CITY OF FRESNO – ADDENDUM NO. 2

RIVER WEST FRESNO EATON TRAIL EXTENSION, PHASE 1

BID FILE NUMBER: 12700455

PAVING

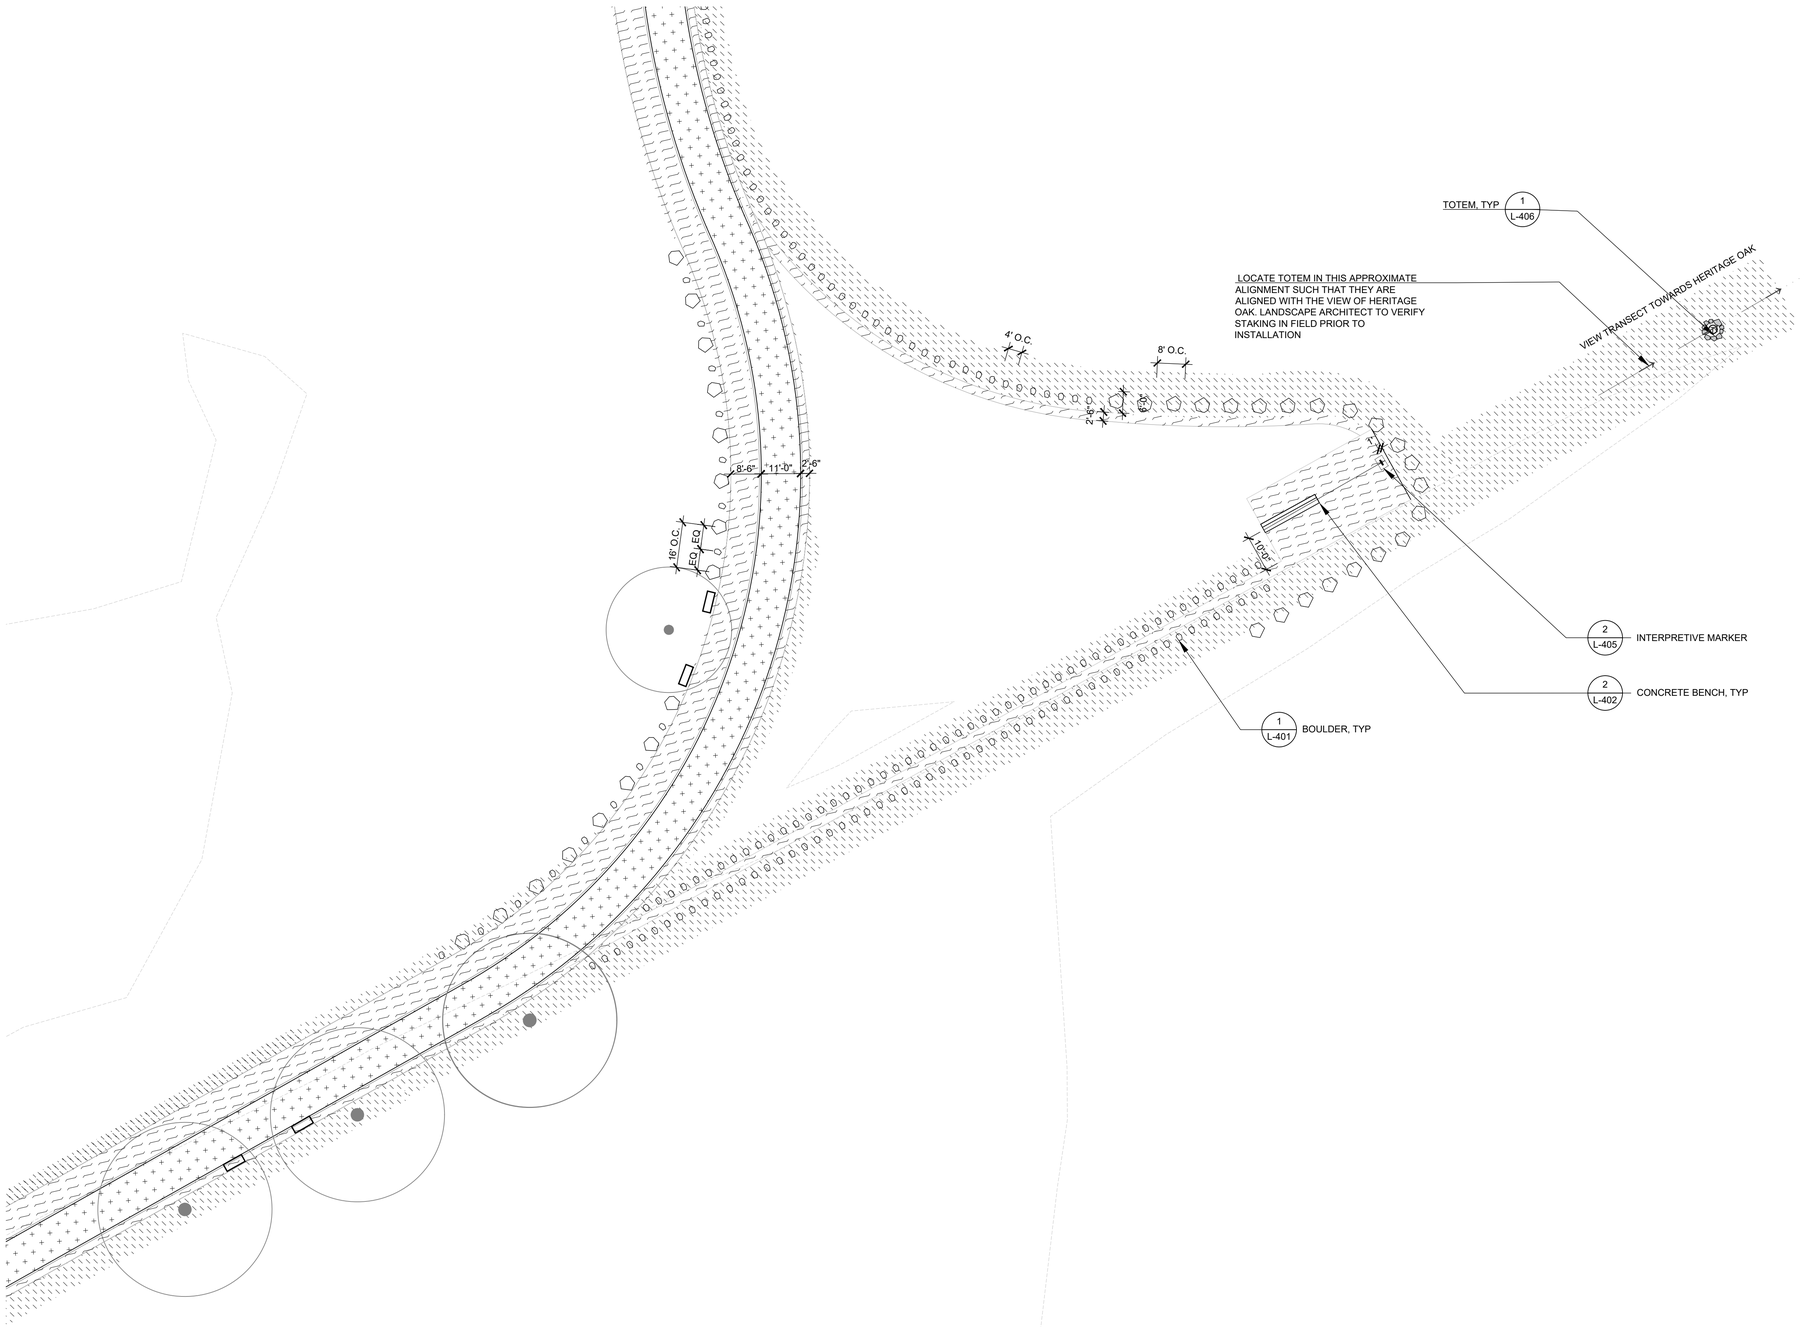
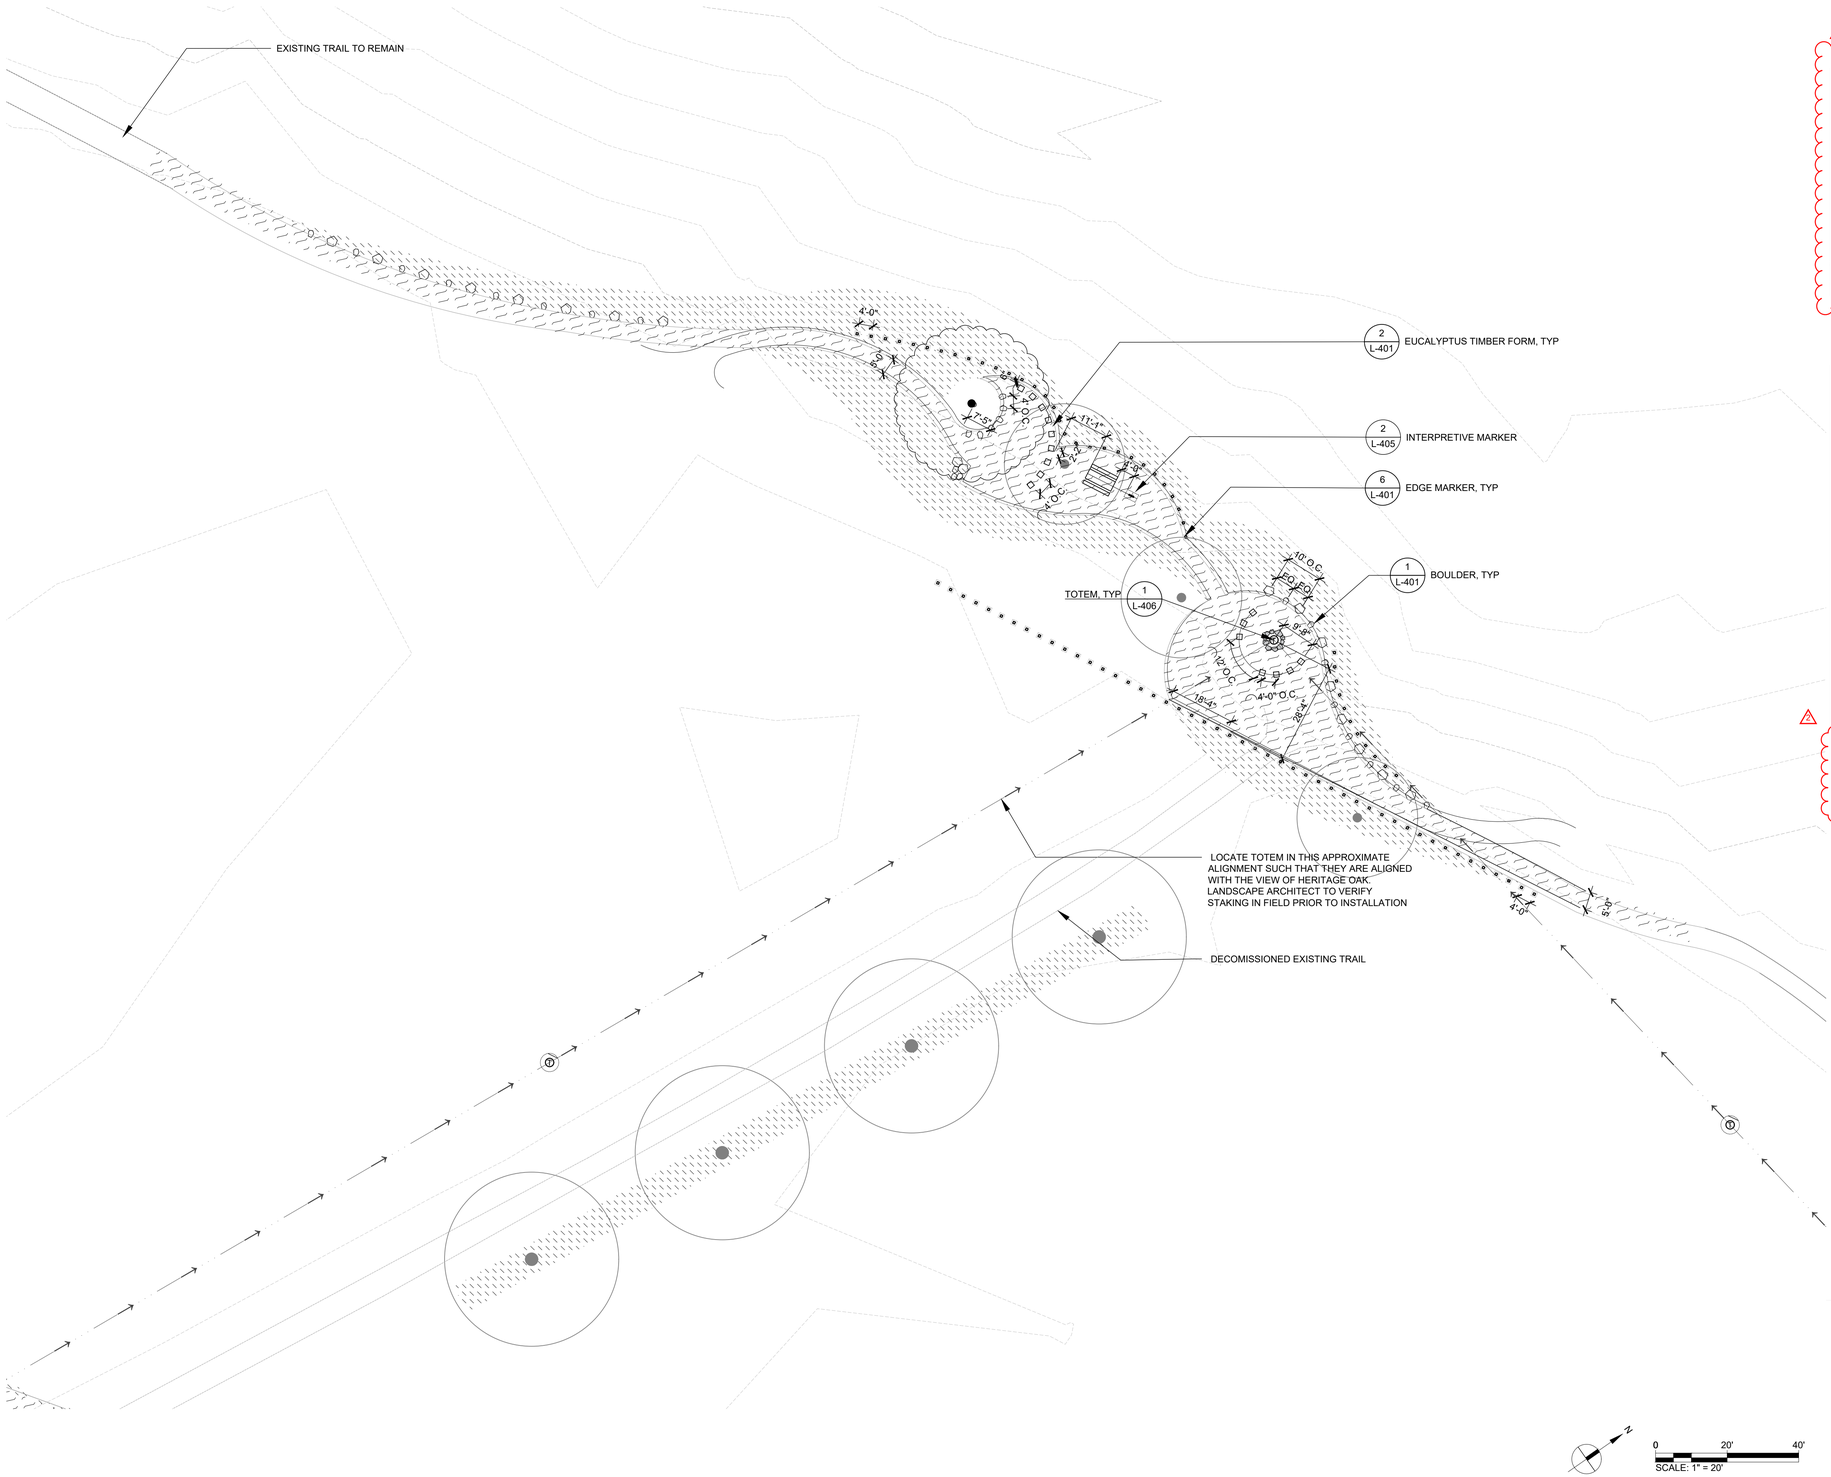
Paving legend on sheets L101 through L110 show gravel tuscany gold in the legend, but the plans don't show the locations of the gravel? Please show the locations of the gravel so the contractor may know where its being installed.

How will the three cast-in-place circular concrete benches shown on plan sheet L-109 be measured and paid for?

The Landscape Plan Sheet Legend shows the Edge Markers with as a quantity of 256 each. Our takeoff counted 527 each. Please review and revise the quantity as necessary.

9. Modification to irrigation connections on Sheet No. 15-E-14657 to Sheet 15-E-14666:

- Remove and Replace Sheet No. 15-E-14657 to Sheet No. 15-E-14666, Sheet 76 to 85 of 133, entirely with Addendum No. 2 Drawing Sheet No. 15-E-14657 (Addendum No.2) to 15-E-14666 (Addendum No.2), (clouded and marked ADDENDUM NO. 2) which modifies the following:
  - Updates paving table to remove gravel.
  - Clarifies the number of circular concrete benches.
  - Clarifies the number of edge markers.

See updated Sheets 76 to 85 of 133, Drawing Sheet No. 15-E-14657 (Addendum No.2) to 15-E-14666 (Addendum No.2), which updates paving table to remove gravel.

There is a total of 100 LF of circular concrete bench. See updated Sheets 76 to 85 of 133, Drawing Sheet No. 15-E-14657 (Addendum No.2) to 15-E-14666 (Addendum No.2), which clarifies the number of circular concrete benches. See updated Specifications Division VI Technical Specifications page 6.12 (Addendum No. 2) Bid Item Description for Bid Item 29 – Site Furnishings.

There is a total of 527 Edge Markers. See updated Sheets 76 to 85 of 133, Drawing Sheet No. 15-E-14657 (Addendum No.2) to 15-E-14666 (Addendum No.2), which clarifies the number of Edge Markers. See updated Specifications Division VI Technical Specifications page 6.12 (Addendum No. 2) Bid Item Description for Bid Item 29 – Site Furnishings.

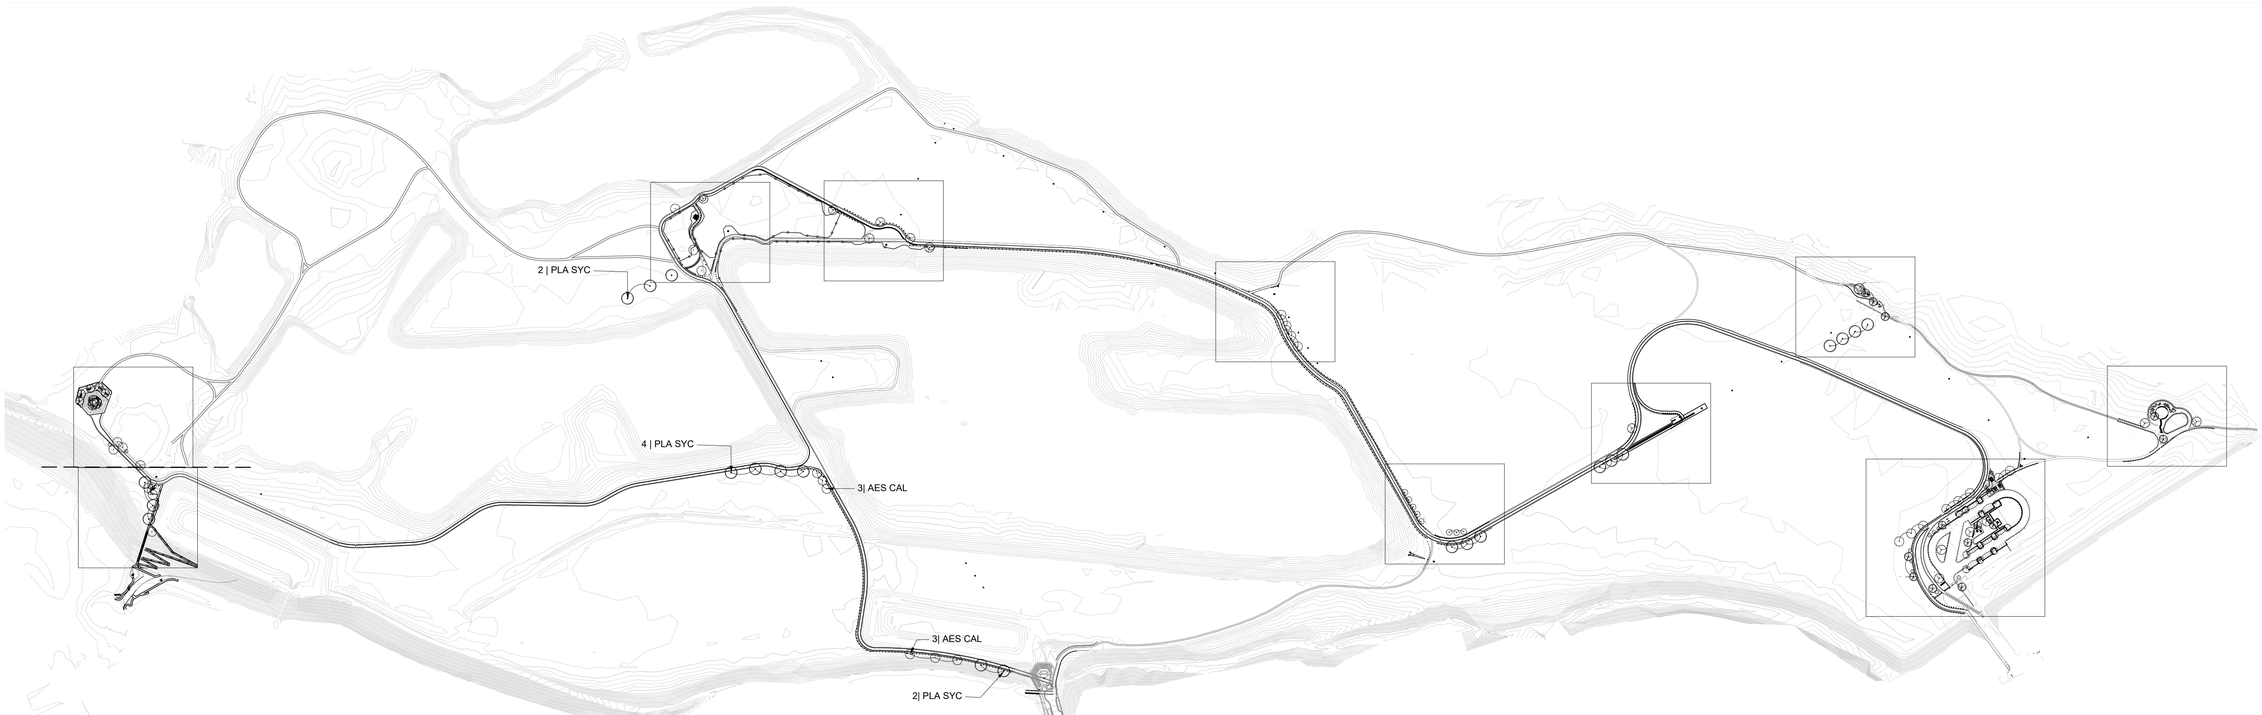
Site planting plan sheet L-200 note b. states to use tree guards 4"x9" for trees in turf area, does that mean only trees in hydroseed area receive the trunk guards?

Please confirm the correct trunk guards to use the 4"x9" per note b. or detail 4 tree planting sheet L-409 to use 3x48" Corrugated tree guard? Please advise which is correct to use.

10. Modification to Sheets 15-E-14667 and Sheet No. 15-E-14687:

- Remove and Replace Sheet No. 15-E-14667 and Sheet No. 15-E-14687, Sheet 86 and 106 of 133, entirely with Addendum No. 2 Drawing Sheet No. 15-E-14667 and 15-E-14687 (Addendum No.2), (clouded and marked ADDENDUM NO. 2) which updates the tree guard notes and details.

Tree guard shall be installed on every proposed tree. See updated Sheets 86 and 106 of 133, Sheet No. 15-E-14667 (Addendum No.2) and 15-E-14687 (Addendum No.2), which updates the tree guard notes and details.

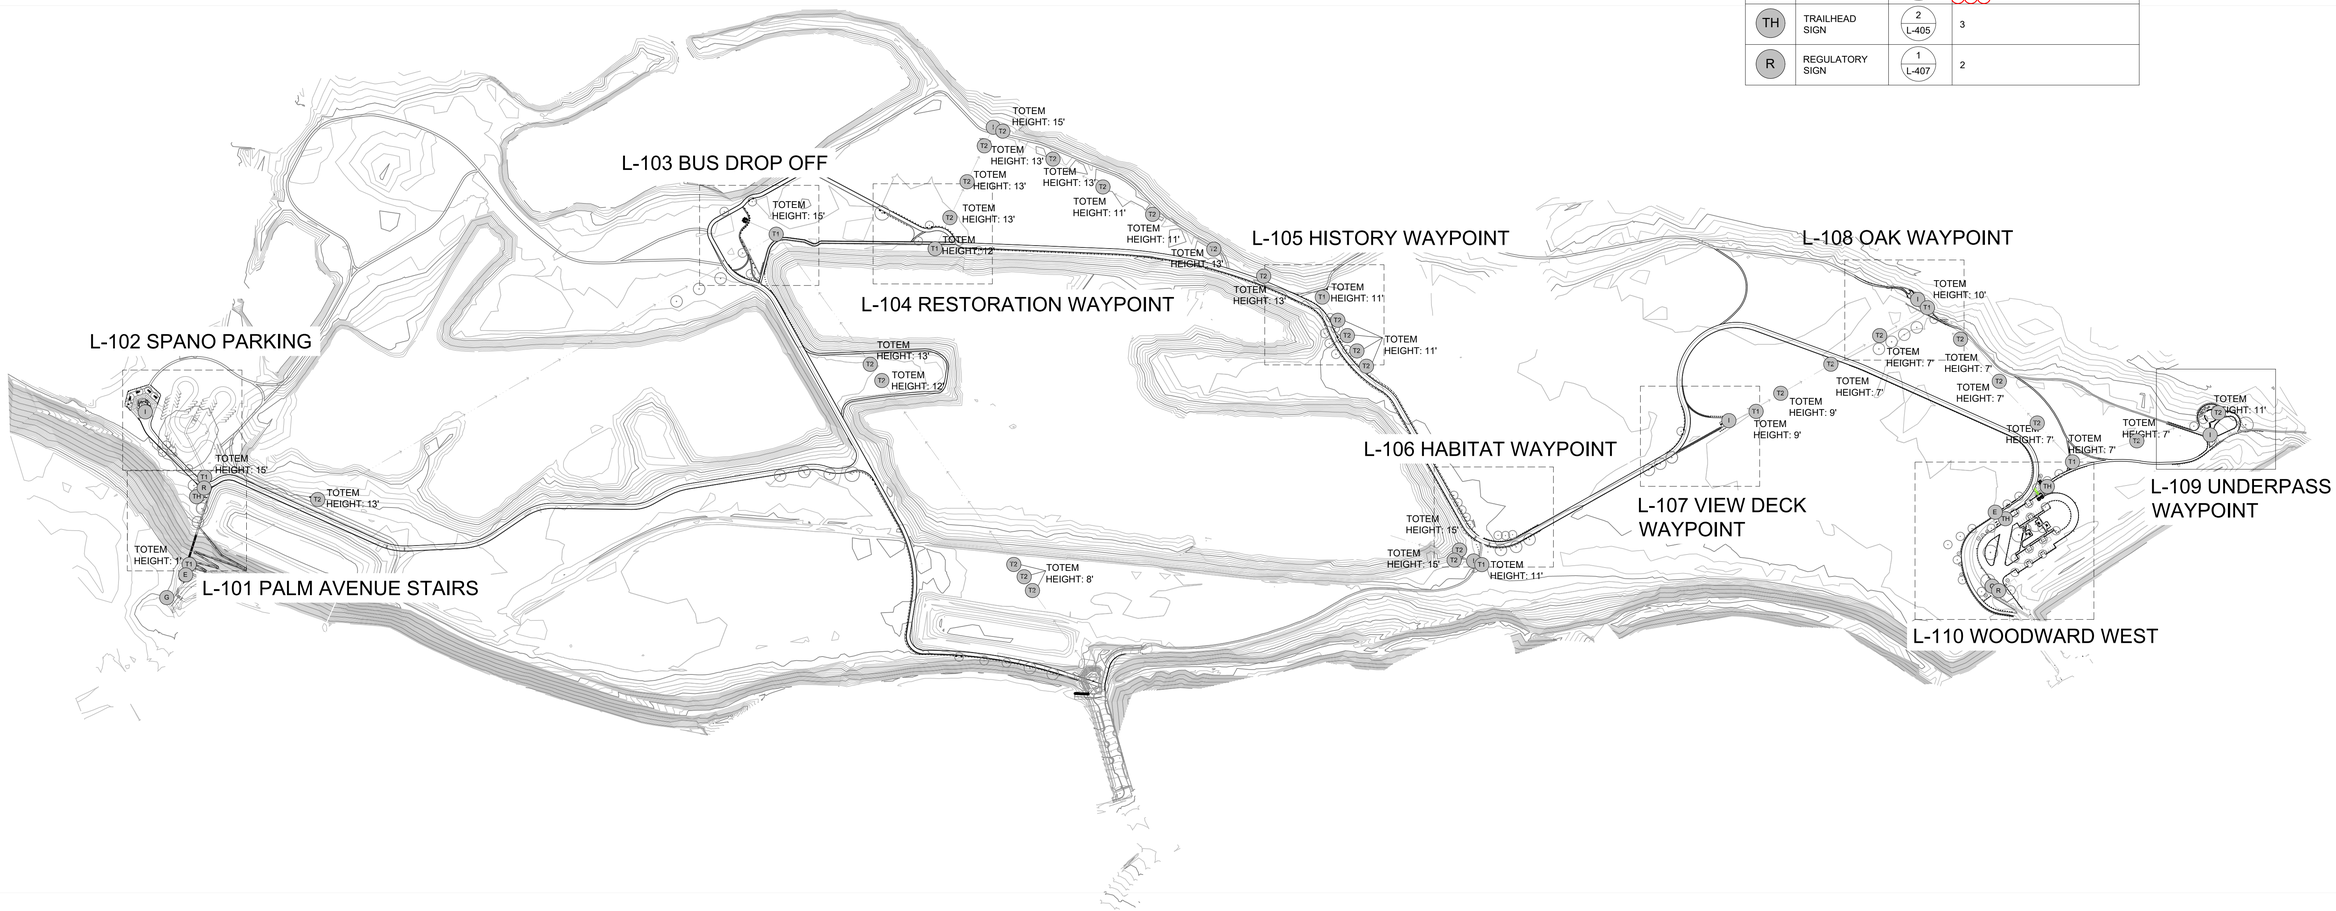
Bid item 29, site furnishing, is calling out for 1 gateway signage. Is there a detail showing this?

12. Modification to Signage Table on Sheet 15-E-14678:

- Remove and Replace Sheet No. 15-E-14678, Sheet 97 of 133, entirely with Addendum No. 2 Drawing Sheet No. 15-E-14678 (Addendum No.2), (clouded and marked ADDENDUM NO. 2) which clarifies the number of signs.

There is a total of 2 Gateway Monuments and 2 Entrance Signs. See updated Sheet 97 of 133, Drawing Sheet No. 15-E-14678 (Addendum No.2), which clarifies the number of signs. See updated Specifications Division VI Technical Specifications page 6.12 (Addendum No. 2) Bid Item Description for Bid Item 29 – Site Furnishings.
